The Commission has issued the enclosed Amendment No. 29 to Facility Operating License No. NPF-30 for the Callaway Plant, Unit 1. This amendment is in response to your application dated June 18, 1987.

The amendment revises the definition of the fully withdrawn shutdown and control rod position from 228 steps to 225 steps or higher.

SAFETY EVALUATION BY THE OFFICE OF NUCLEAR REACTOR REGULATION
RELATED TO AMENDMENT NO. 29 TO FACILITY OPERATING LICENSE NO. NPF-30

UNION ELECTRIC COMPANY
CALLAWAY PLANT, UNIT 1
DOCKET NO. STN 50-483

FIGURE 3.1-1

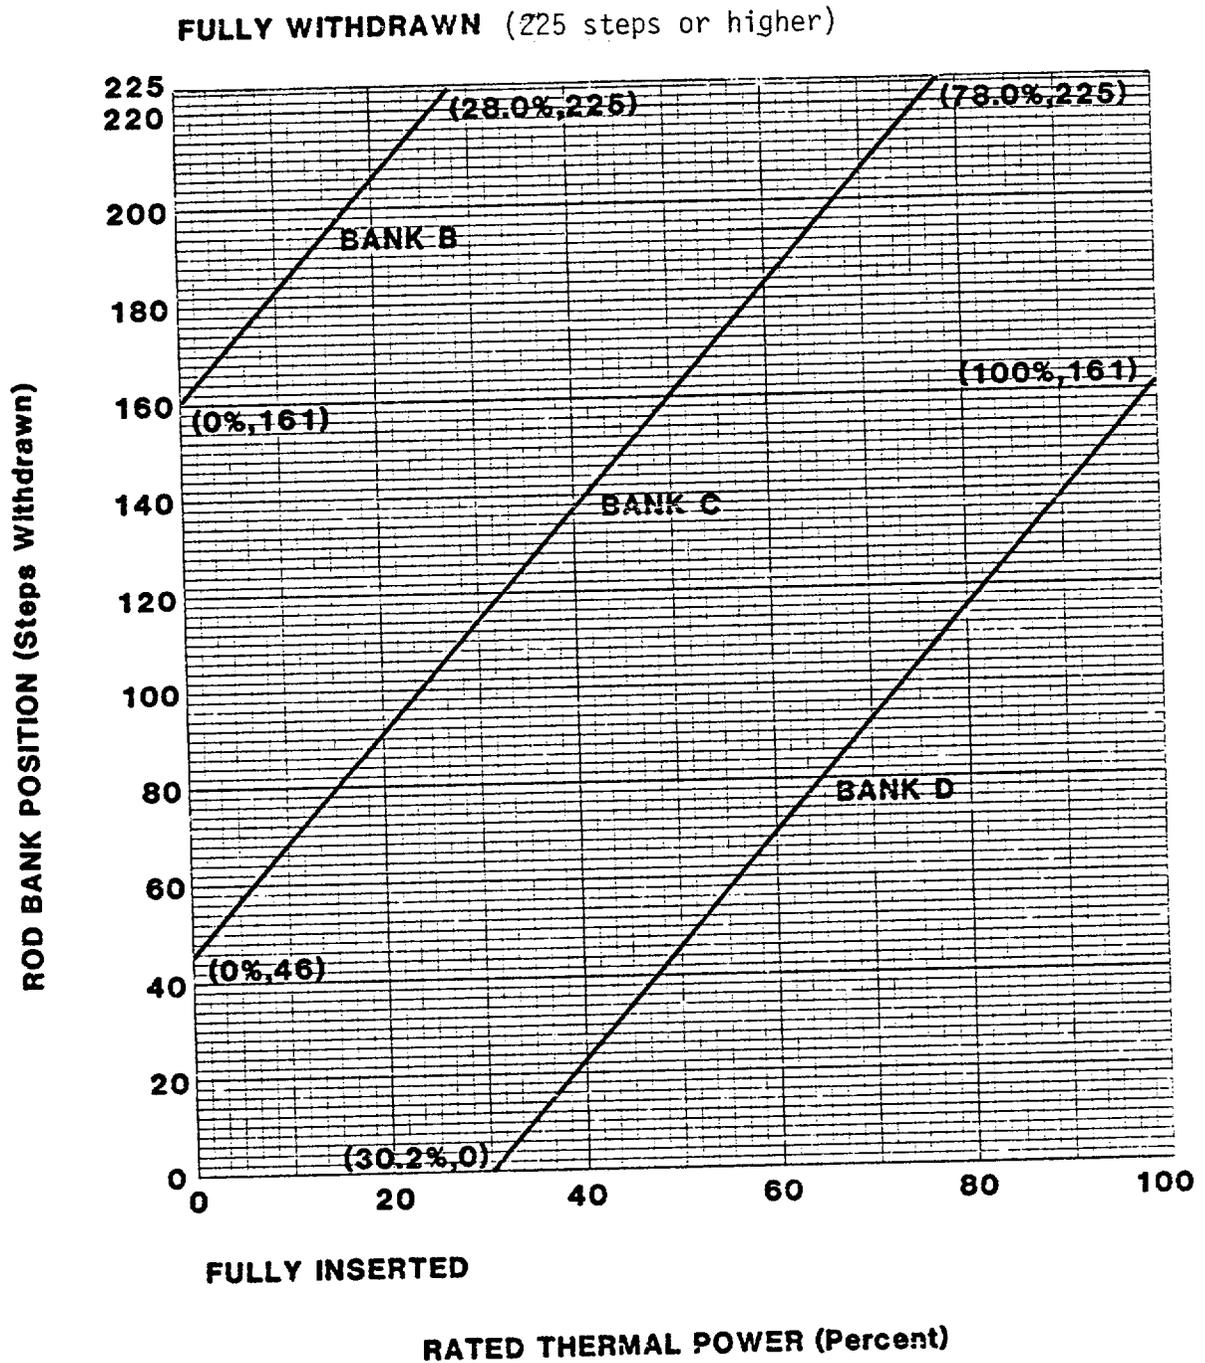
In a letter dated June 18, 1987, Union Electric Company (the licensee) proposed changes to the Callaway Technical Specification 3.1.3.5 and to Figure 3.1-1. The proposed changes state that all shutdown rods shall be withdrawn 225 steps or higher, and revise Figure 3.1-1 to show 225 steps as fully withdrawn.

The licensee proposed the change to minimize localized rod cluster control assembly (RCCA) wear at the top of the control rods. The proposed technical specification change will allow operation with the RCCA's inserted three steps into the reactor from their normal withdrawn position of 228 steps. At 225 steps withdrawn, the RCCA's are only 0.3 inches into the active fuel region. Since the top region of the core has such low worth, the resultant power distribution perturbations are calculated to be negligible and can be accommodated with available margin. Similarly, the effect on shutdown margin is minimal (0.02% $\Delta\rho$), and can be accommodated by available excess shutdown margin (1.95% $\Delta\rho$ at BOL and 0.61% $\Delta\rho$ at EOL).

Based on the above evaluation, the staff agrees that the proposed change has essentially negligible effect and is, therefore, acceptable. The staff did, however, suggest and the licensee agreed to slight changes in the wording of the technical specification. By doing this, the Callaway technical specifications are consistent with those of other Westinghouse plants which have requested this change.
